## ADDENDUM NO.2

### PROJECT – ECA @ CEC Modernization, Renovation & Addition

RFP NO. 21-032 RRR  
APS PROJECT # 507  
NIGP Code: 90927; 90928; 909

EP102  
ADDENDUM No. 2  
EXHIBIT 06

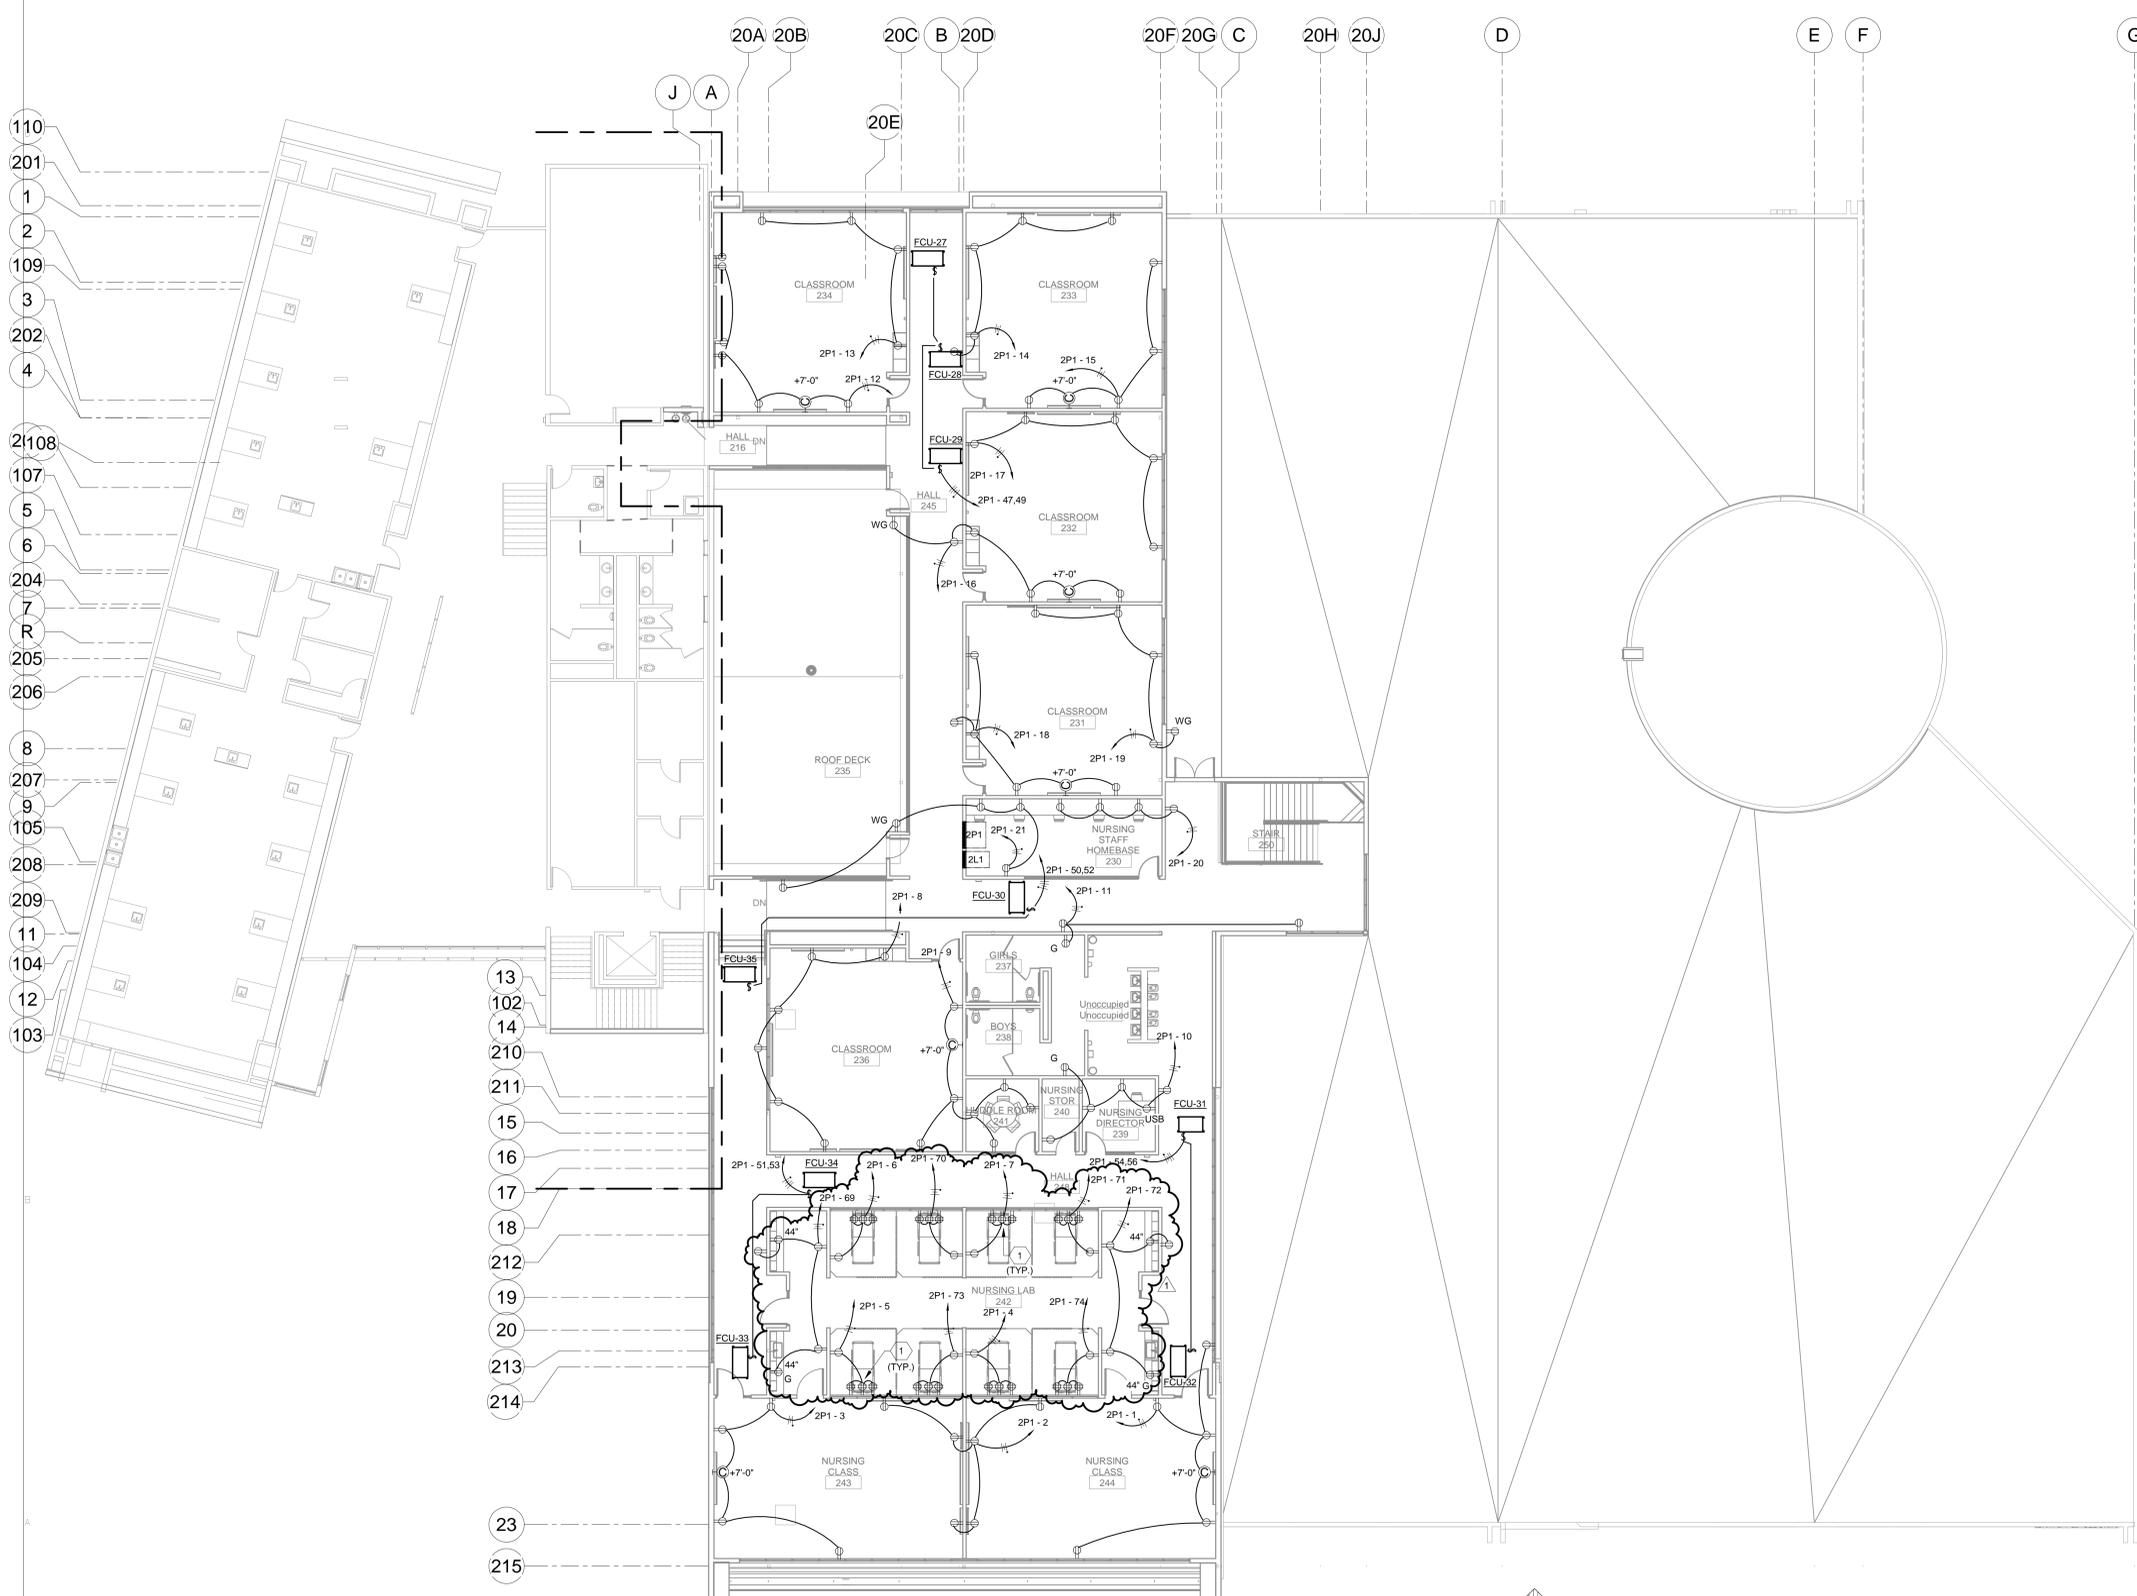
- a. CHANGE head wall receptacles in NURSING LAB 242 per revised drawing, see **Exhibit 06**.

1. PROVIDE OUTLETS IN BED HEAD BOARD. REFER TO ARCHITECTURAL ELEVATION FOR OUTLET DETAIL AND REQUIREMENTS.
